# section 7

**SCHEMATIC CHANGES AND EQUIPMENT DIFFERENCES**

*30S-1 RF Linear Amplifier, Schematic Diagram  
 Figure 7-1 (Sheet A)*

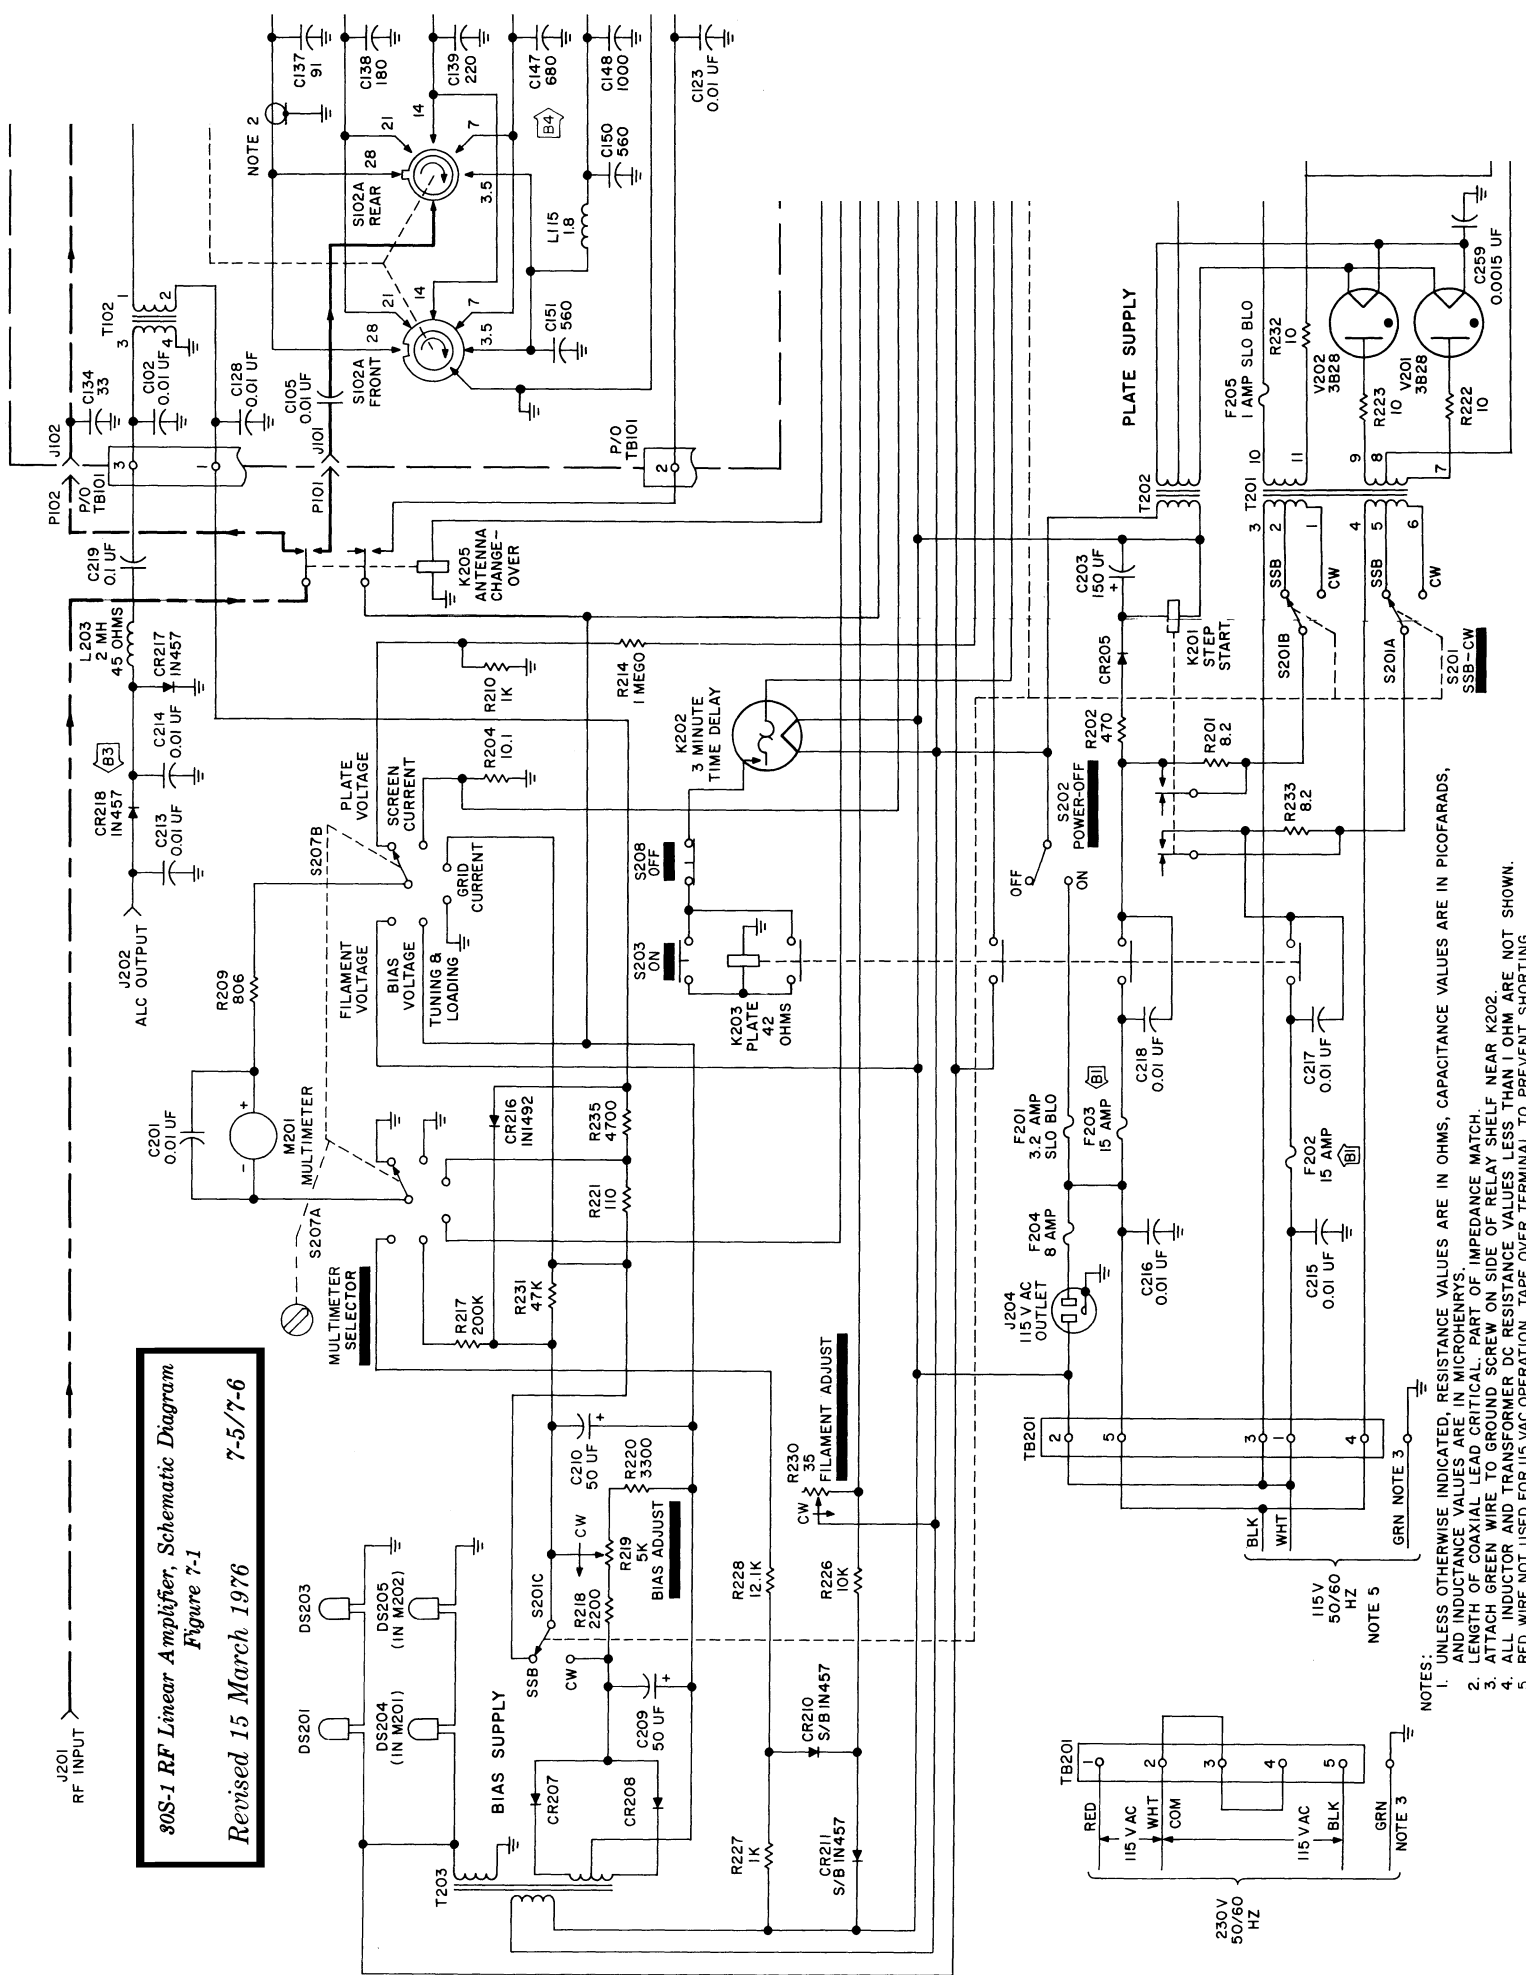
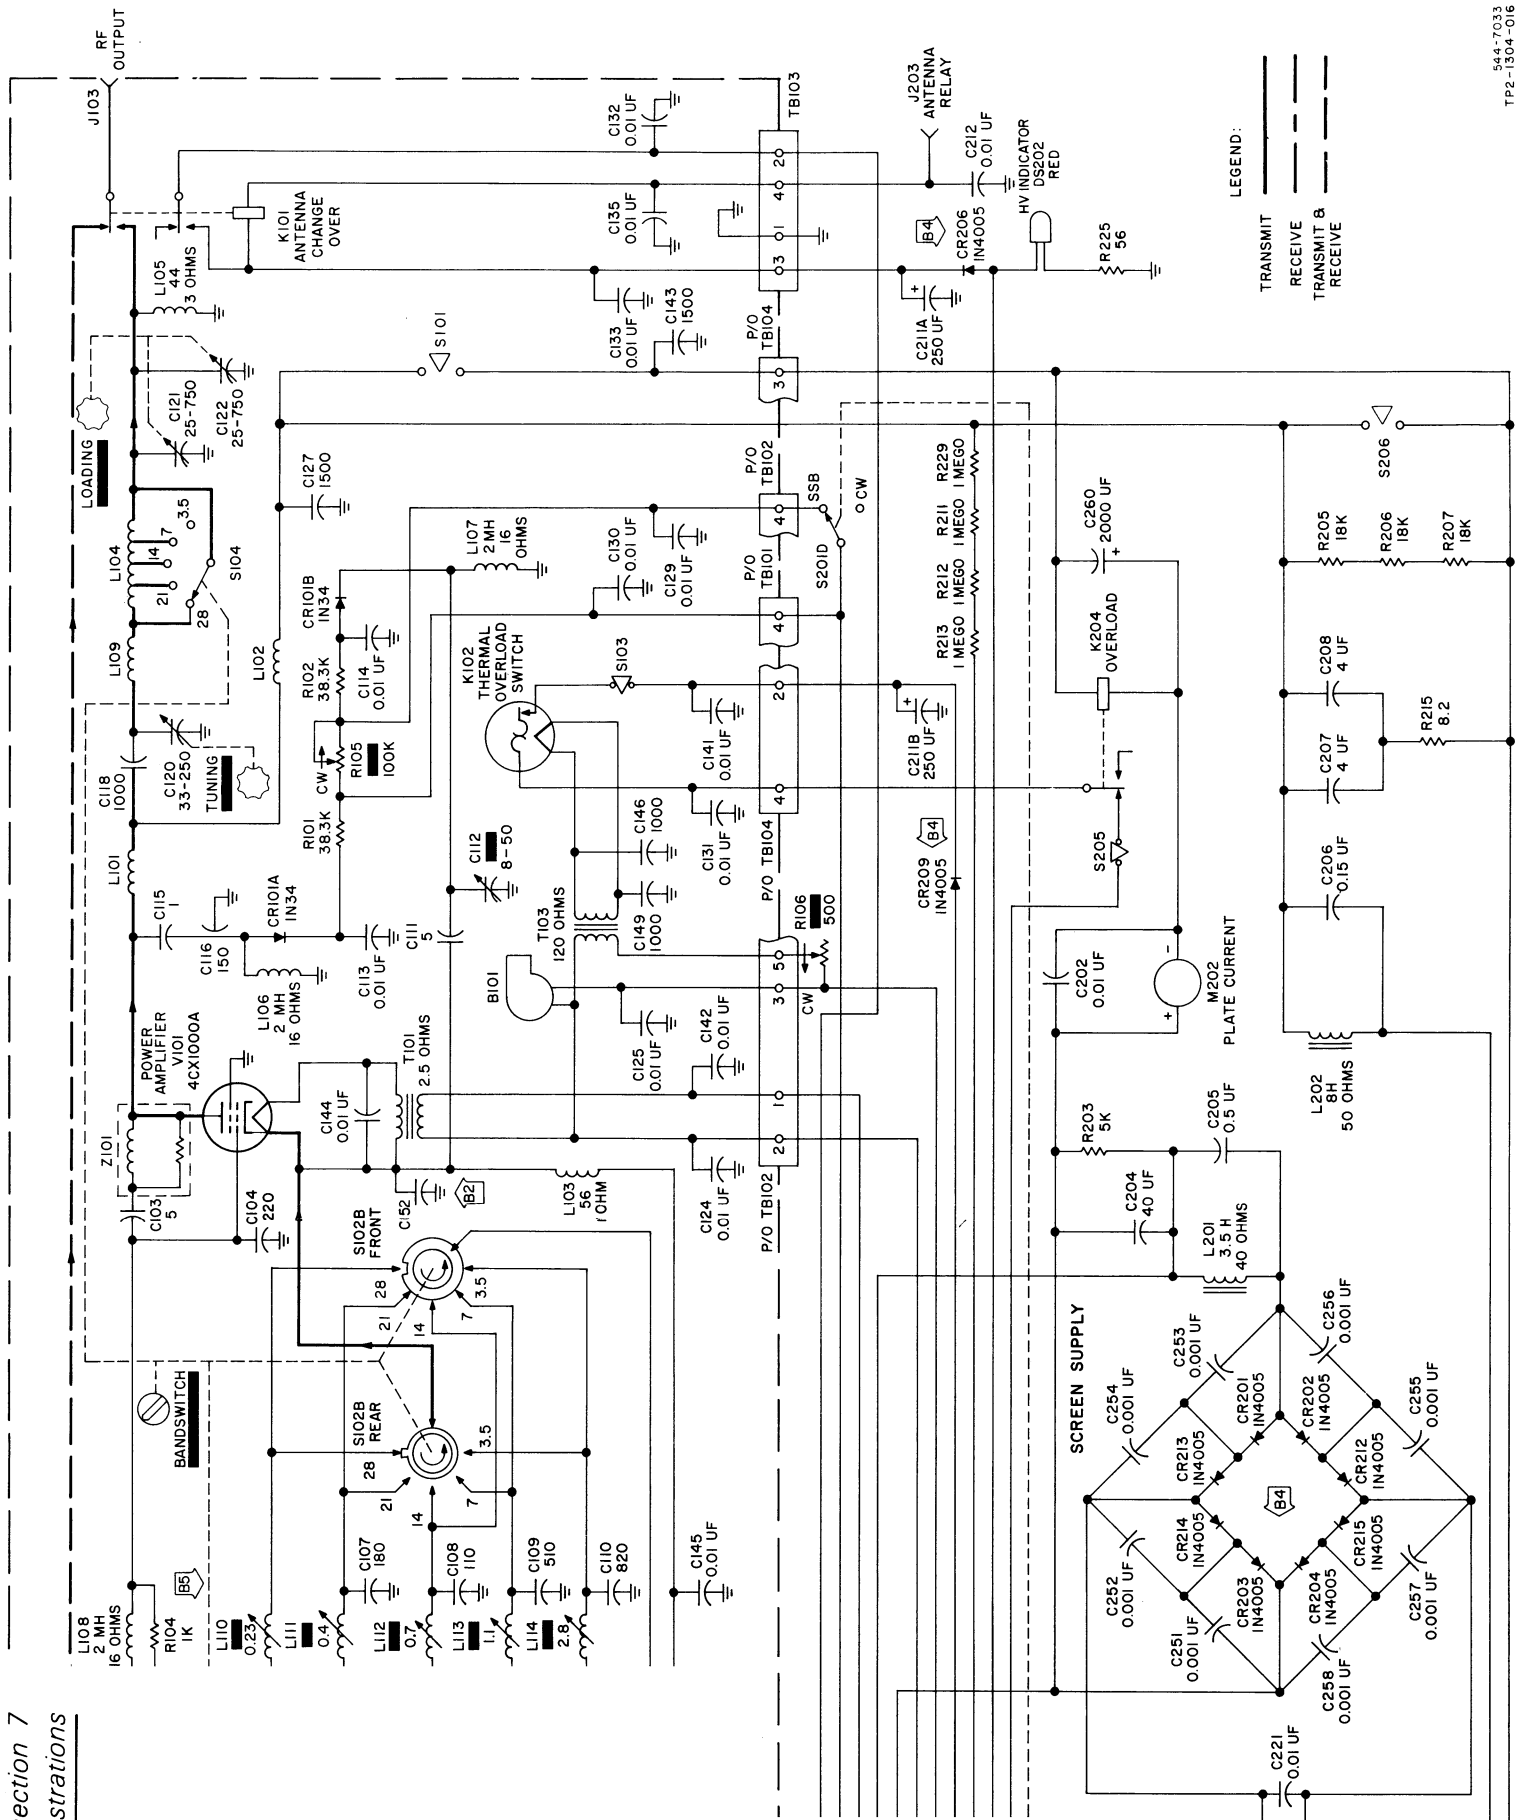
IDENTIFIER	DESCRIPTION
B1	Fuses F202 and F203 were changed from 12 to 15 A. If either fuse needs replacing, it is recommended that both be replaced with the 15-A value.
B2	Capacitor C152 is a factor test select component, from 15 to 47 pF, used in many units. It is selected to provide minimum swr with a 28-MHz input. If this component is in the unit and needs replacing, replace it with the existing value. If it is not in the unit, it should not be added.
B3	Tube V203 (12AL5) was replaced with diodes CR217 and CR218 (1N457). V203 was located between capacitors C213 and C214 with pin 7 connected to connector J202, pins 1 and 2 connected to capacitor C114-choke L203, and pin 5 grounded. If this circuit needs repair, maintain the existing configuration.
B4	<p>Diodes CR201 through CR204 and CR212 through CR215 were changed from 1N1492 to 1N4005. If any of these diodes need replacing, it is recommended that the 1N4005 be used.</p> <p>Diodes CR206 and CR209 were changed from 1N1084 to 1N4005. If one, or both, of these diodes needs replacing, it is recommended that the 1N4005 be used. If the unit originally used 1N1084 diodes, it will contain diode holders for these diodes. The 1N4005 diode leads can be soldered in place without removing the diode holders. When the factory changed to the 1N4005 diodes, terminal board TB211 was elongated to provide space to mount CR206 and CR209. With this change, the Collins part number of TB211 was changed from 545-6150-002 to 609-0691-001.</p>

B5	C147 was changed from 650 to 680 pF.
